**CROSS-SECTIONS**  
**NAPOLITANO ADDITION**  
**6 SAMUEL RD. PORTLAND, ME**

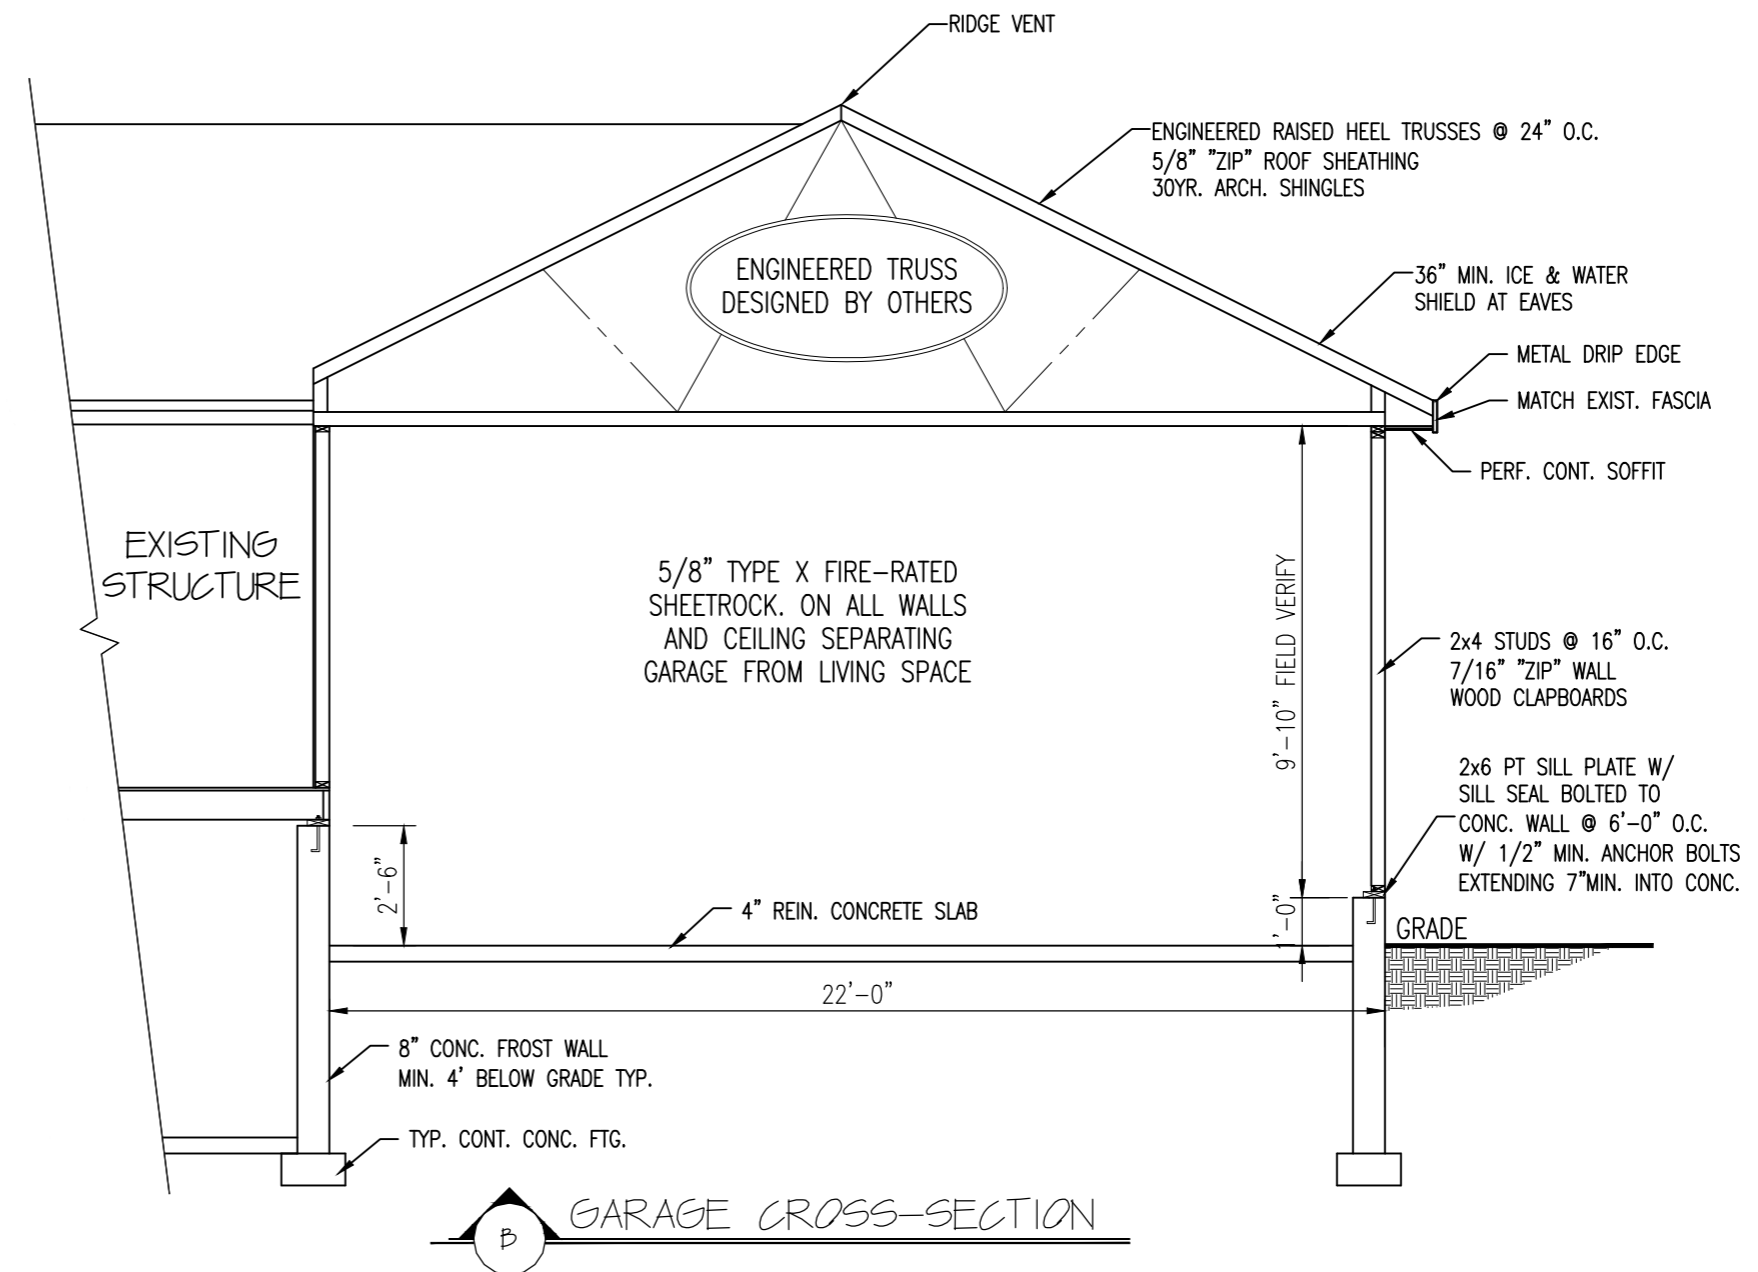
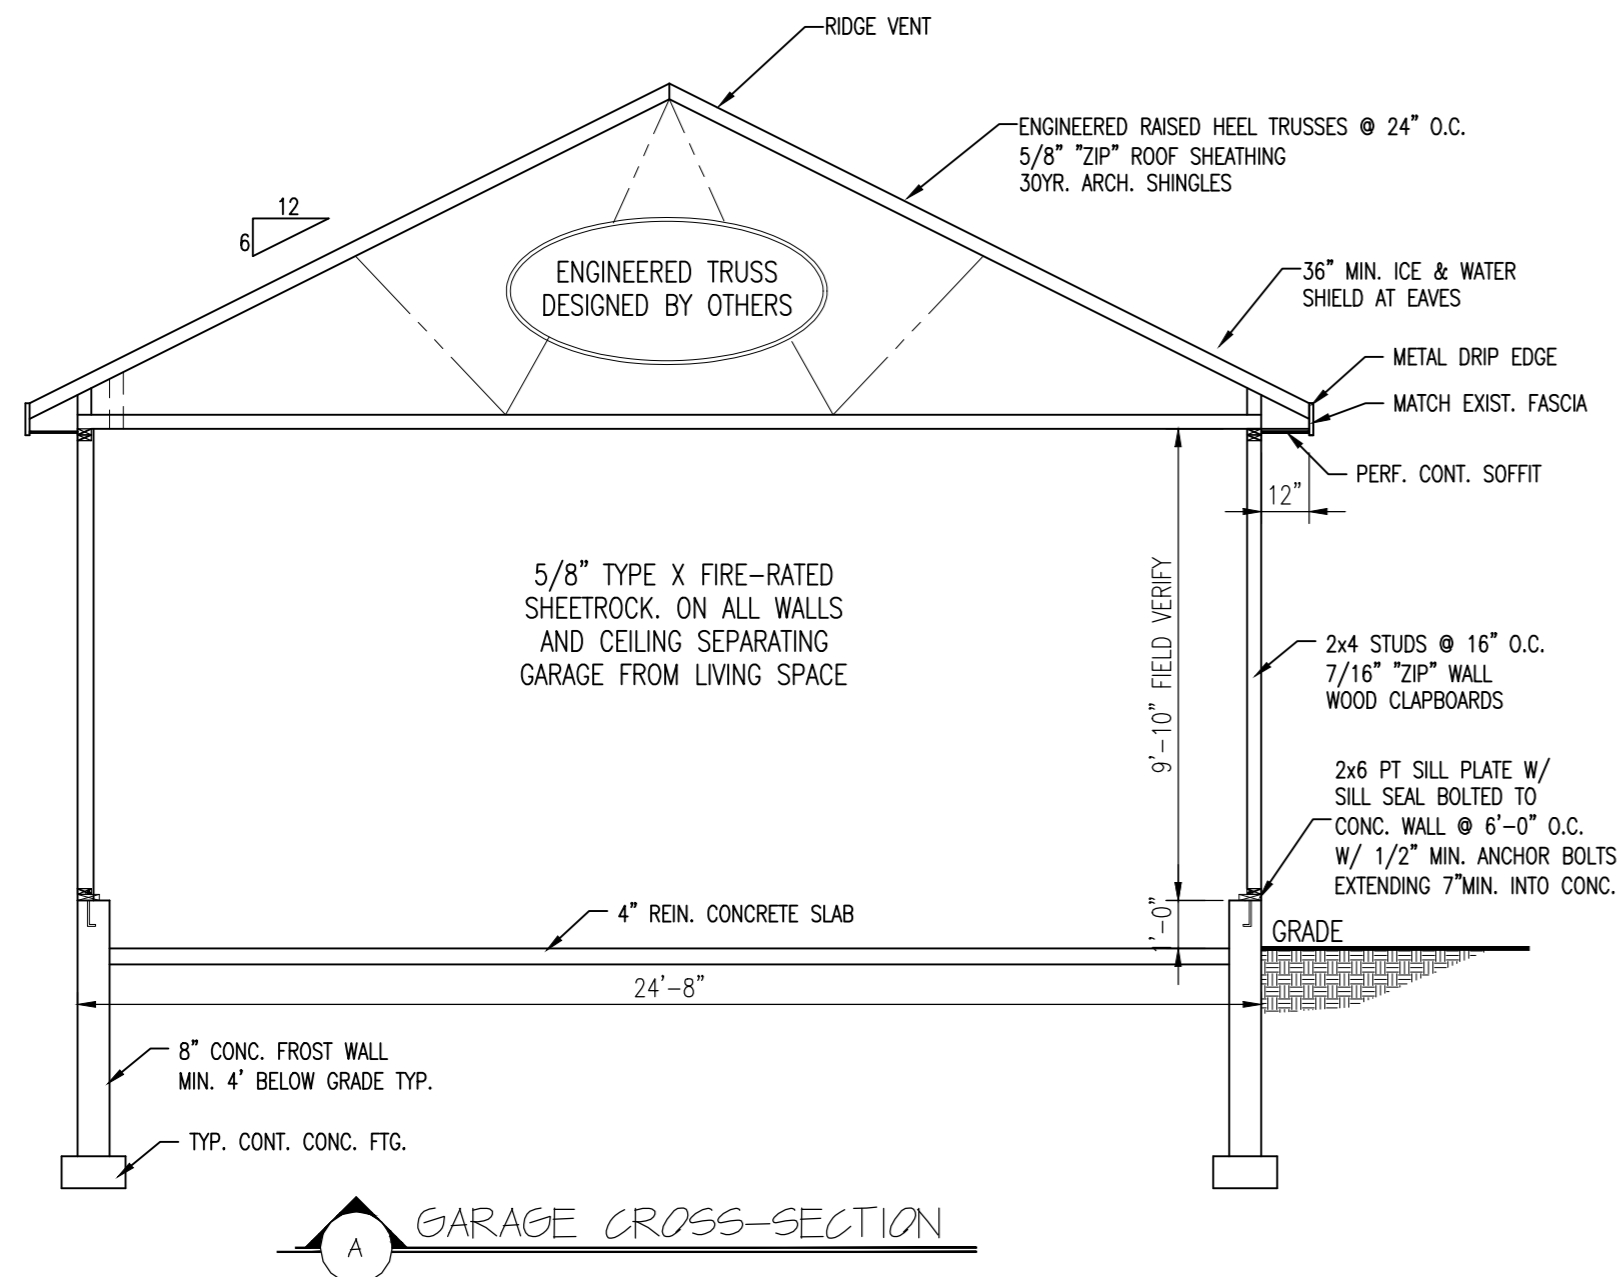
Clarify if garage is insulated. If so, provide R values.

Provide specifications for engineered trusses.

Garage is not insulated.

See attached PDFs with complete truss specifications.
